Re: Tract N-1-B Watershed Subdivison - Sketch Plat Submittal

TRACTS N-1-B, WATERSHED SUBDIVISION zoned **PC**, located on **ARROYO VISTA** between **118TH ST** and **98TH ST** containing approximately 60.08 acre(s). (J-8)

REQUEST: Sketch Plat review for Tract N-1-B Watershed
IDO -2022

Development Facilitation Team (DFT) – Review Comments

PLAT OF
TRACTS N-1-A & N-1-B
WATERSHED SUBDIVISION
(A REPLAT OF TRACT N-1,
WATERSHED SUBDIVISION)
PROJECTED SECTIONS 17 AND 18,
TOWNSHIP 10 NORTH, RANGE 2 EAST,
N.M.P.M.
ALBUQUERQUE,
BERNALILLO COUNTY, NEW MEXICO
AUGUST, 2023

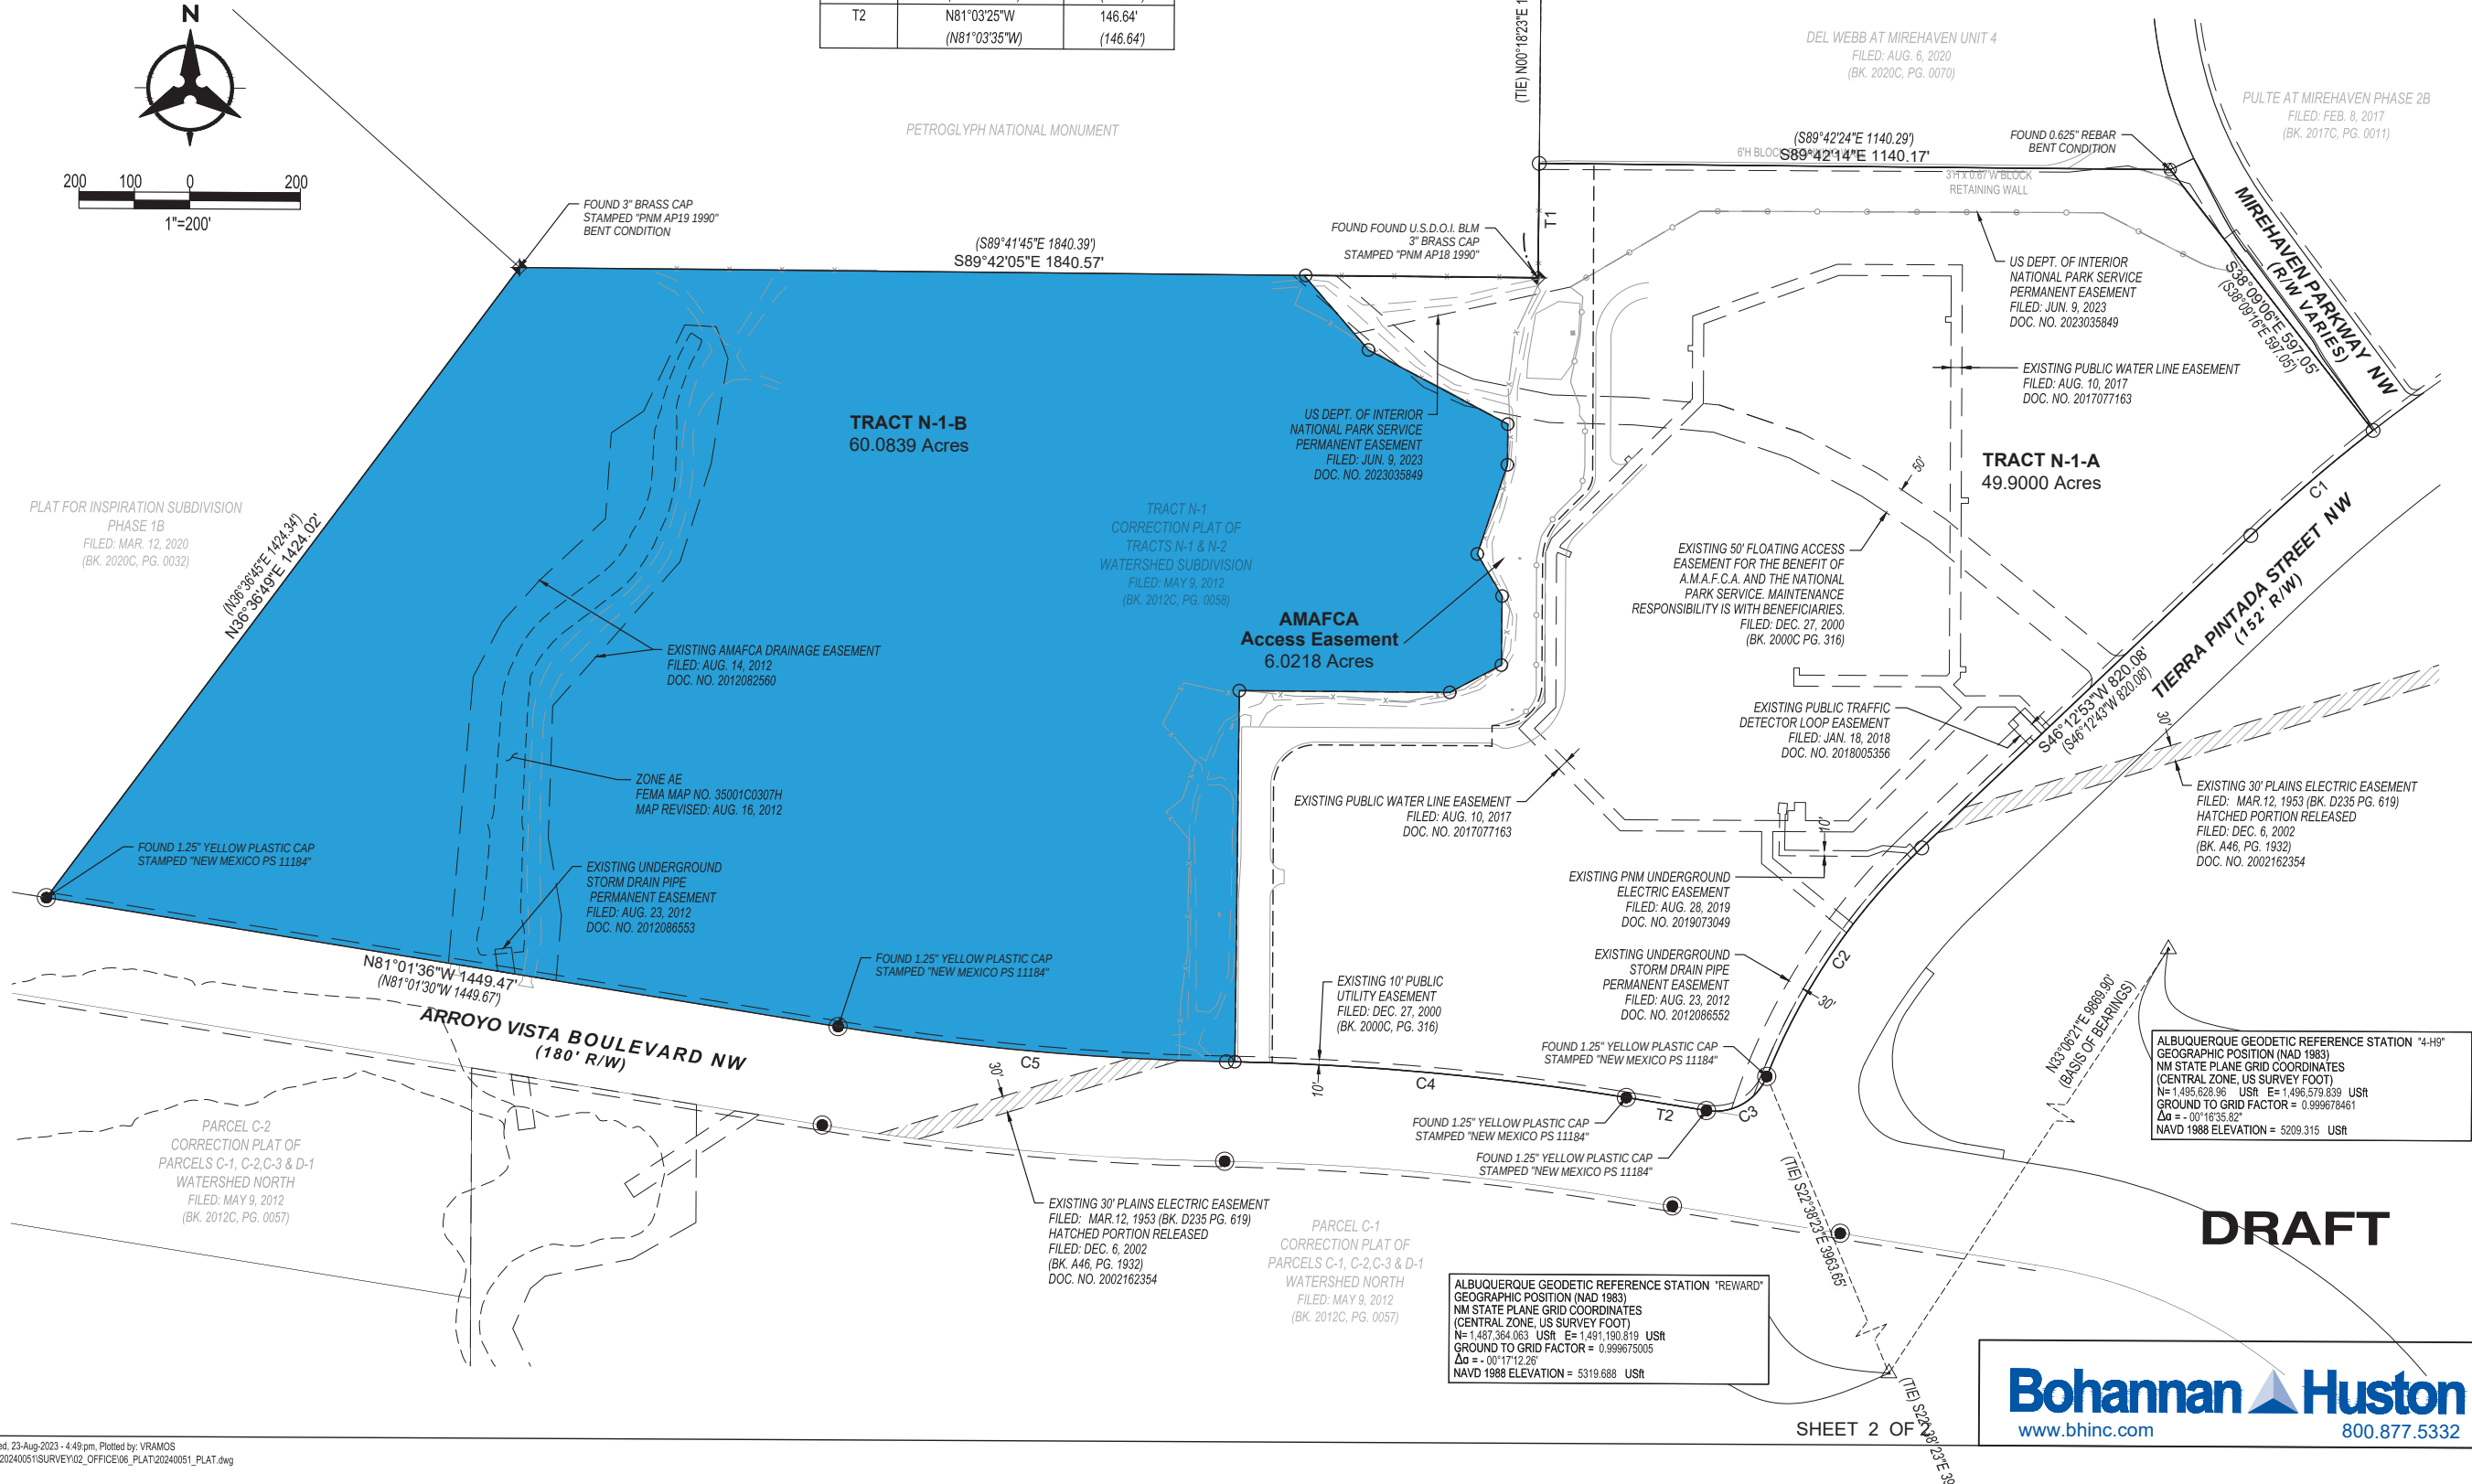
- A previous sketch plat was reviewed April 17, 2024. That Sketch Plat review request was for a Bulk Land Plat, subdividing an existing tract, Tract N-1 of the Watershed subdivision, into Tract N-1-B at 60.0839-acres in size and Tract N-1-A at 49.9-acres in size. **Tract N-1-A and Tract N-1-B still need to be created. Tract N-1-B could then be further subdivided.**

- A Bulk Land Plat application could be acceptable to transfer Tract N-1-B to another owner.
- The site area meets the minimum lot size requirements for a Bulk Land Plat per 6-6-6(J(1)(b)(2) of the IDO.

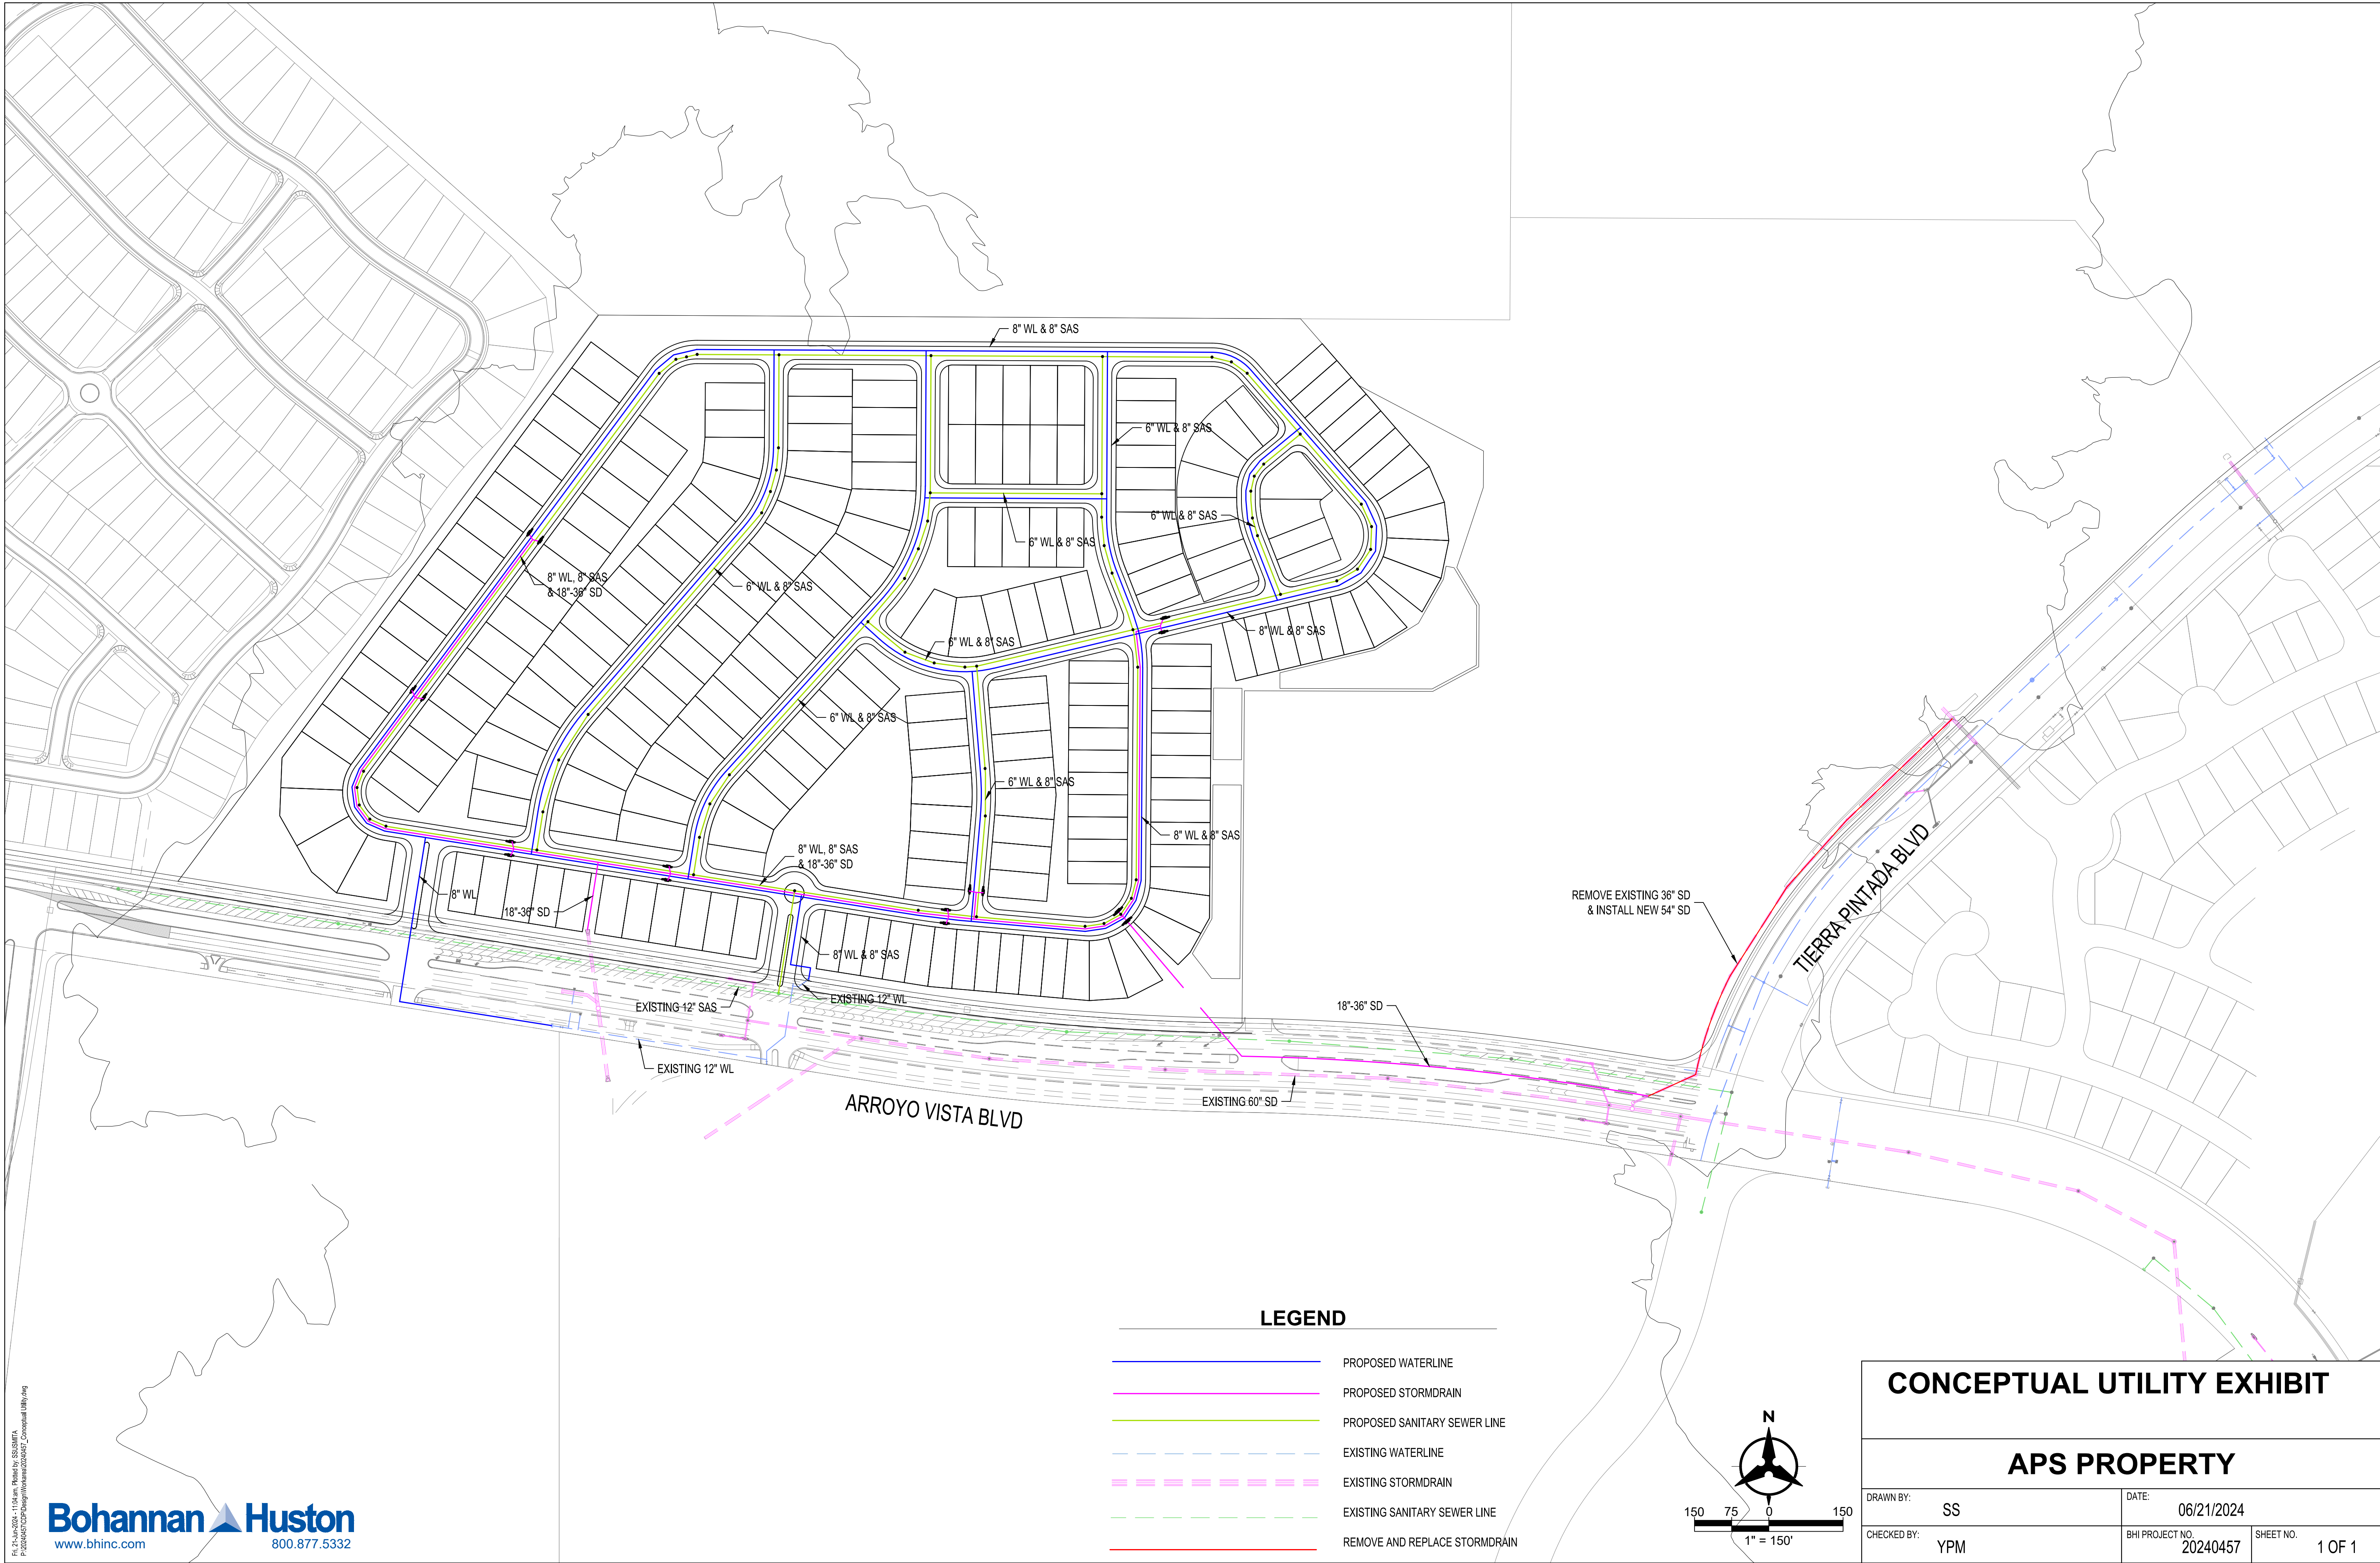
1. Request an availability/serviceability statement online at the following link:
http://www.abcwua.org/Availability_Statements.aspx. Requests shall include fire marshal requirements. An executed statement must be obtained prior to approval.
2. Regarding the comment for water, please provide a maximum pad elevation for the site to determine if there is any need for 5W infrastructure.
 - a. Note that the highest contour I see for the site based on our mapping system is right at the 5W/4W pressure zone boundary at 5485 feet which is evident the entire site currently sits within the 4W pressure zone thus not requiring a PRV to provide pressure to the site.
3. As proposed the site is on a really long dead end line and will require some sort of loop. Perhaps to the adjacent site on APS site which will create a good looped water system to provide redundancy for the future development.

1. Arroyo Vista is a Principal Arterial and requires a 6' sidewalks with a 5' to 6' landscape buffer. There is an existing multiuse trail along here which meets sidewalk requirements.
2. All internal roads would be local roads and require 5' sidewalk with a 4' to 6' landscape buffer.
3. Prior to site plan an approved TCL is required. Also, please submit a Traffic Scoping Form to Curtis Cherne (ccherne@cabq.gov) to determine if a TIS is required.

- Hydrology will need to approve a Conceptual Grading & Drainage Plan prior to platting.
- The infrastructure list will be needed for Preliminary Plat.
- Hydrology will also need AMAFCA's approval prior to plat approval.

- Platting applications would be subject to review and approval by the City of Albuquerque/Development Hearing Officer (DHO). residential would be >>>>>
- The western tract (proposed Tract N-1-B in this sketch plat) is a proposed residential subdivision, and not an educational land use. The parcel is subject to the requirements of the Westland Framework Plan and the IDO and DPM where the Framework Plan is silent. As the Westland Framework Plan depicts the subject property as an Education land use, any other future land uses on the site requires an amendment of the Westland Framework Plan, requiring EPC or City Council approval of the amendment. DRS Planning staff advises the applicant to schedule a PRT meeting with UDD staff regarding this step.

This site requires a Site Plan EPC prior to subdivision of land with the DHO.

It is noted that a single-loaded street has been placed on the edge of the subdivision adjacent to Petroglyph National Monument which meets of the requirements of 5-2(J).

It would appear that you have been able to keep some block lengths under 600 feet, but some are not.

5.4.F.2.b Residential lots shall avoid layouts where the rear lot line is adjacent to a collector or arterial street. Local frontage roads may be used within a subdivision to avoid locating residential rear yard walls along collector and arterial streets.
